Project	IEEE 802.16 Broadband Wireless Access Working Group < http://ieee802.org/16 >
Title	Amendment to Idle Mode Service Primitives
Date Submitted	2007-03-13
Source(s)	Jeehyeon Na, Jaesun Cha, JungMo Moon and Sangho Lee jhna@etri.re.kr ETRI 161 Gajeong-dong, Yuseong-gu Daejeon 305-700 Korea
Re:	Contribution on comments to IEEE 802.16g/D8
Abstract	Re-definition of Idle mode service primitives in section 14.2.4.2
Purpose	Adoption
Notice	This document has been prepared to assist IEEE 802.16. It is offered as a basis for discussion and is not binding on the contributing individual(s) or organization(s). The material in this document is subject to change in form and content after further study. The contributor(s) reserve(s) the right to add, amend or withdraw material contained herein.
Release	The contributor grants a free, irrevocable license to the IEEE to incorporate text contained in this contribution, and any modifications thereof, in the creation of an IEEE Standards publication; to copyright in the IEEE's name any IEEE Standards publication even though it may include portions of this contribution; and at the IEEE's sole discretion to permit others to reproduce in whole or in pa

Figure 479—Subscriber mode transition diagram at NCMS [\(on BS or MS side\)](#)

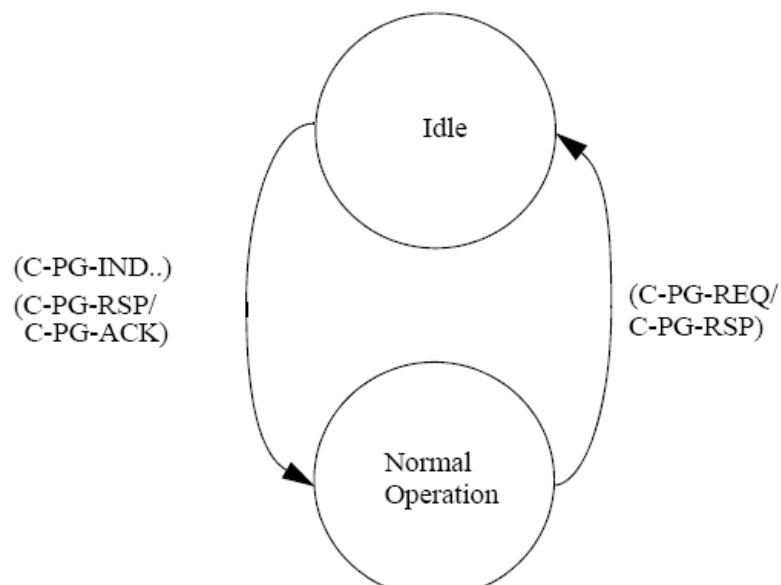
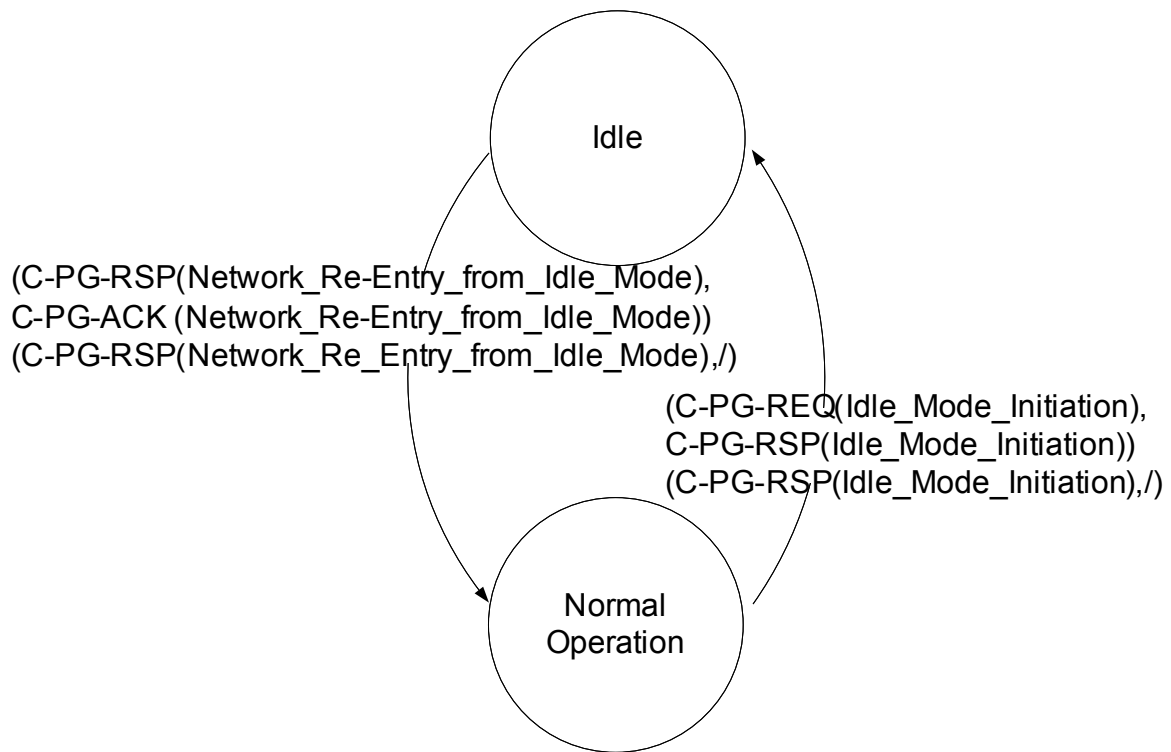
Subscriber mode management is described as informative in section 14.2.4 and it is managed at an MS, a BS and an NCMS. Figure 479 which shows subscriber mode transition diagram at an NCMS is not clear whether for an NCMS on a BS and an MS side or not.

Therefore, we clarify figure 479 and the related texts in order to be used both NCMS at an MS and a BS side.

Figure 479 shows Subscriber Mode transition diagram at the NCMS with service primitives related with the Subscriber Mode transition. Subscriber Mode transition from Normal Operation to Idle Mode is performed by exchanging C-PG-REQ and C-PG-RSP between ~~a BS~~ an 802.16 entity and the NCMS after successful DREG-REQ message from the MS with De-Registration_Request_Code=0x01 or DREG-CMD message from the BS with Action Code = 0x05, where C-PG-REQ and C-PG-RSP are defined in 14.2.4.2.1 and 14.2.4.2.2, respectively. Subscriber Mode transition from Idle Mode to Normal Operation is initiated after exchanging ~~C-PG-IND, C-PG-RSP;~~ C-PG-IND, C-PG-RSP; and C-PG-ACK between an 802.16 entity ~~BS~~ and the NCMS, where ~~C-PG-IND, C-PG-RSP,~~ C-PG-IND, C-PG-RSP, and C-PG-ACK are defined in ~~14.2.4.2.4,~~ 14.2.4.2.2, and 14.2.4.2.3, respectively.

Figure 480 – Idle mode initiation (NCMS on the MS side)

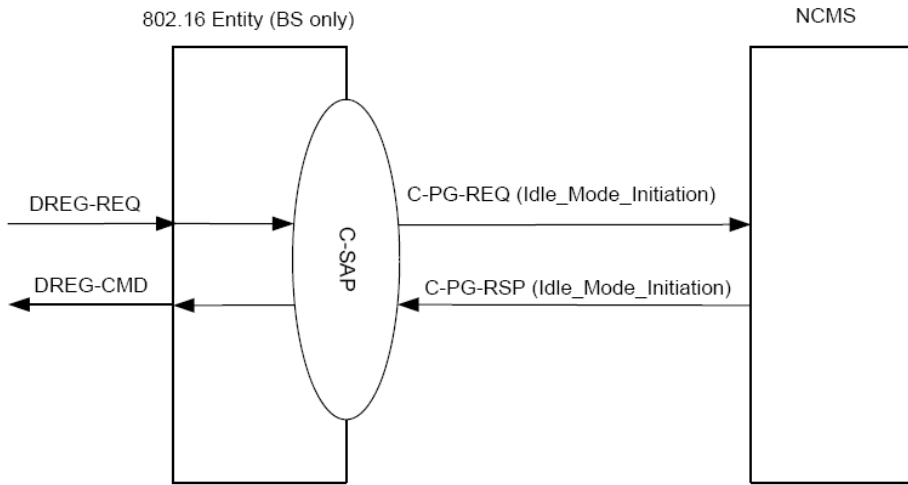
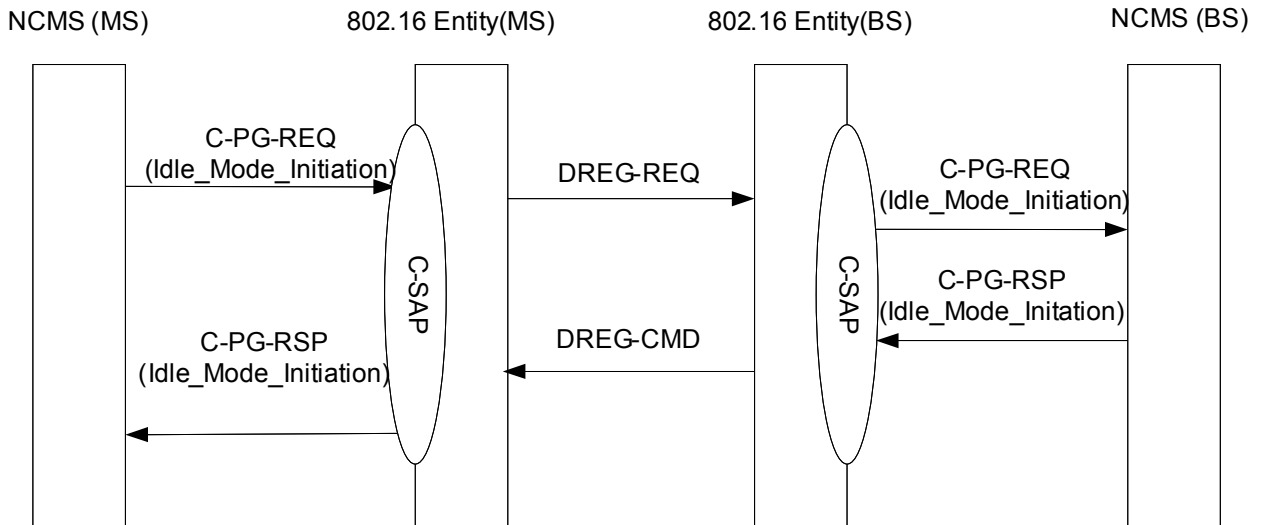
Therefore, we propose to change figure 480, 482, 483 to the figures which are included the service primitives between an 802.16 entity (MS) and an NCMS on the MS side and modify the related service primitives parameters in this contribution. And we also correct some editorial texts.

[Change the figure 480 and its title to as follows]

Figure 482- Paging Announcement

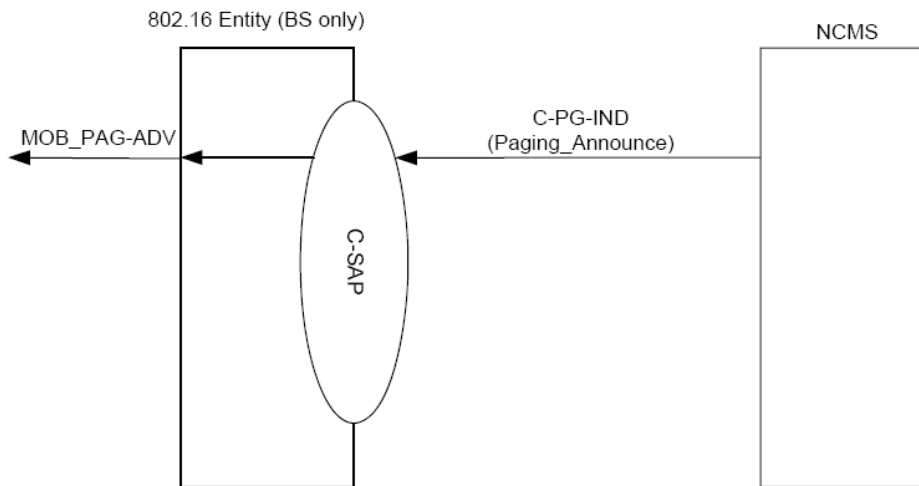
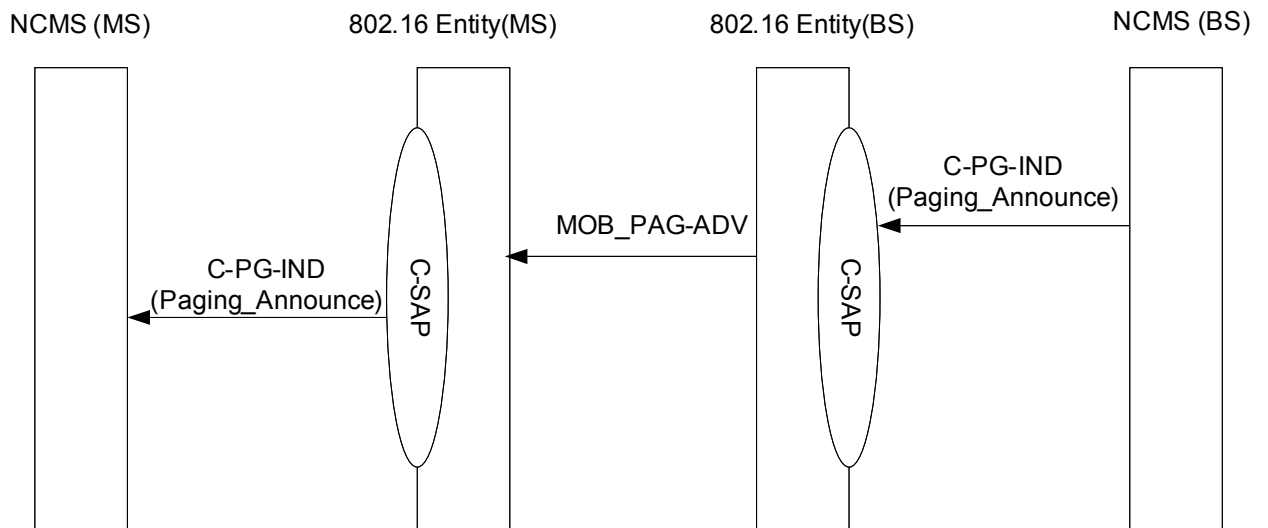
[Change the figure 482 to the following figure Section 14.2.4.2]

Figure 483- Network re-entry from Idle mode primitives

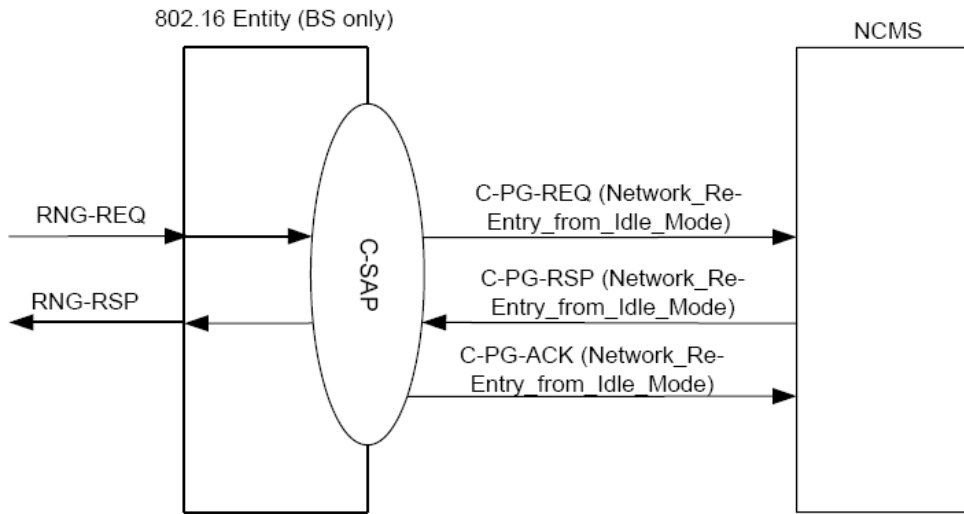
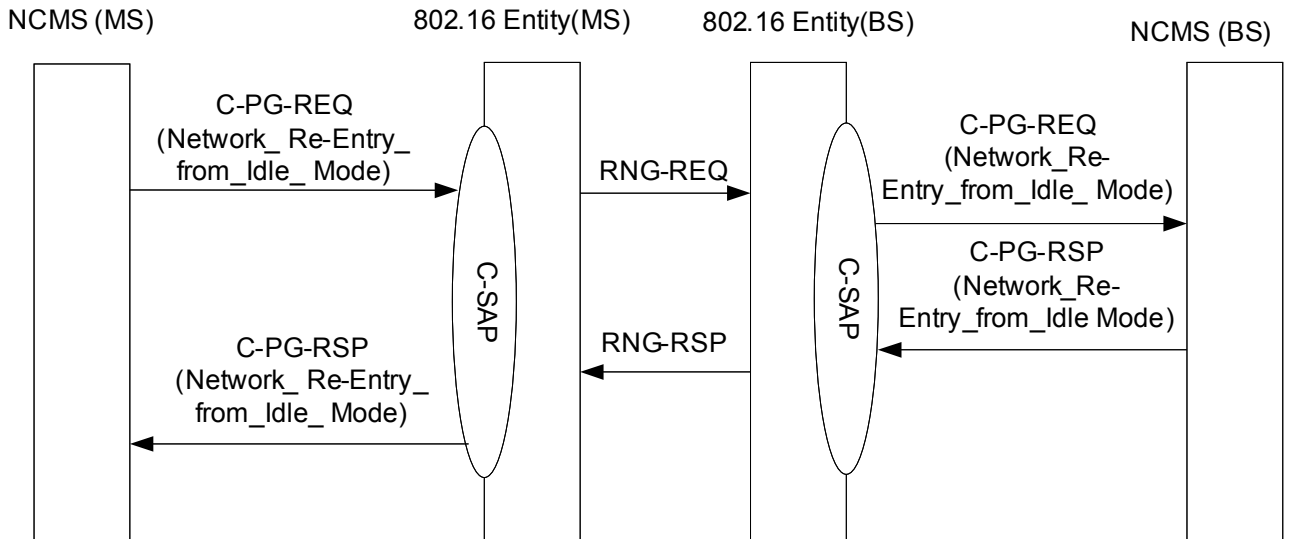
[Change the figure 483 to the following figure in 14.2.4.2]
